Work Order ID 89729

Item ID: D3394-043 Accept *N900040100* Setup Start *NS1*
 Revision ID: Stop *NS2*
 Item Name: Lug Assembly
 Start Date: 8/31/12 Start Qty: 40.00 *40* Cust Item ID:
 Required Date: 9/28/12 Req'd Qty: 40.00 *40* Customer:
 Reference:

DRAWING NO. D3394	TITLE LUG	REV. B	DART AEROSPACE LTD ENGINEERING ORDER		D.E.O. NO. D3394-B-1	SHEET NO. SHEET 1 OF 1	SCALE NTS
DRAWN AJS	CHECKED	MFG. APPR.	APPROVED		DE APPR.		
DATE 09.11.04	DATE 09.11.04	DATE 09.11.04	DATE 09.11.04		DATE 09.11.04

DRAWING NO. D3394	TITLE LUG	REV. B	DART AEROSPACE USA, INC ENGINEERING ORDER		D.E.O. NO. D3394-B-2	SHEET NO. SHEET 1 OF 1	SCALE NTS
DRAWN <i>GP</i>	CHECKED <i>Sc</i>	MFG. APPR. <i>M</i>	APPROVED <i>MP</i>		DE APPR. <i>MP</i>		
DATE 11.05.02	DATE 11.05.09	DATE 11.05.08	DATE 11.05.08		DATE 11.05.09

SHEET 4 ZONE A,1 MODIFY SECTION A-A AS SHOWN:

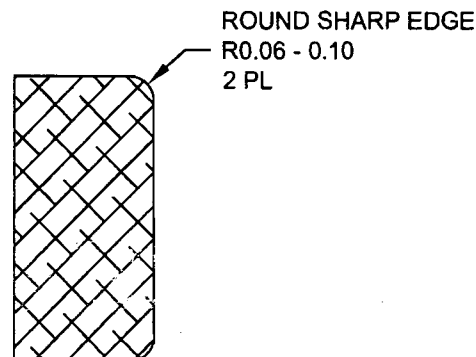
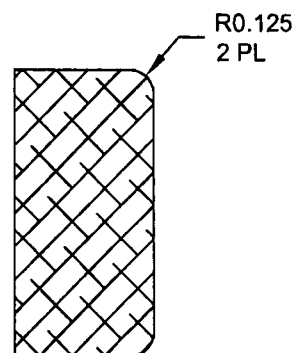
REASON: DRAFTING ERROR

IS:

WAS:

D3394-1RG LUG (SHOWN)
D3394-3RG/-5RG LUGS (SIMILAR)
D3394-041RG/-043RG/-045RG LUG ASSEMBLIES (SIMILAR)

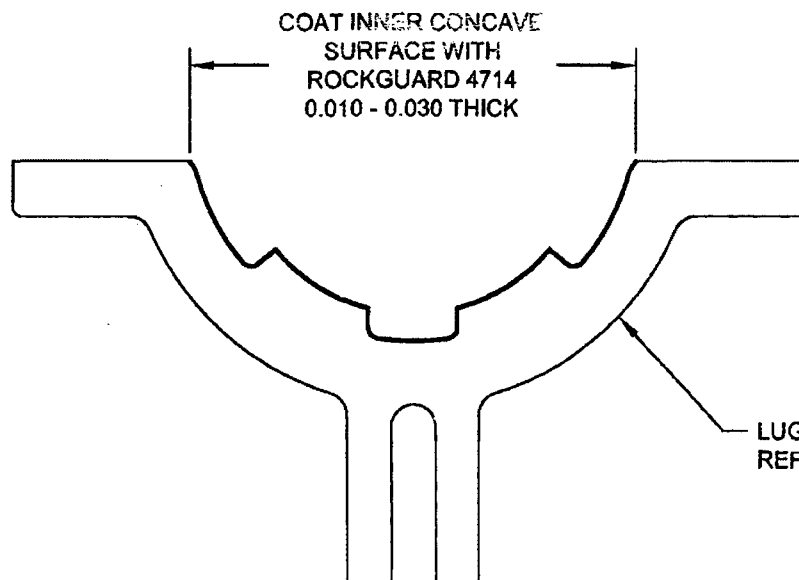
ADD D3394-xRG OPTION

D3394-xRG MOUNTING LUGS ARE INDENTICAL TO D3394-x MOUNTING LUGS, HOWEVER AFTER FINISH, COAT INNER CONCAVE SURFACE WITH "PLUS ONE ROCKGUARD 4714" AS SHOWN BELOW.
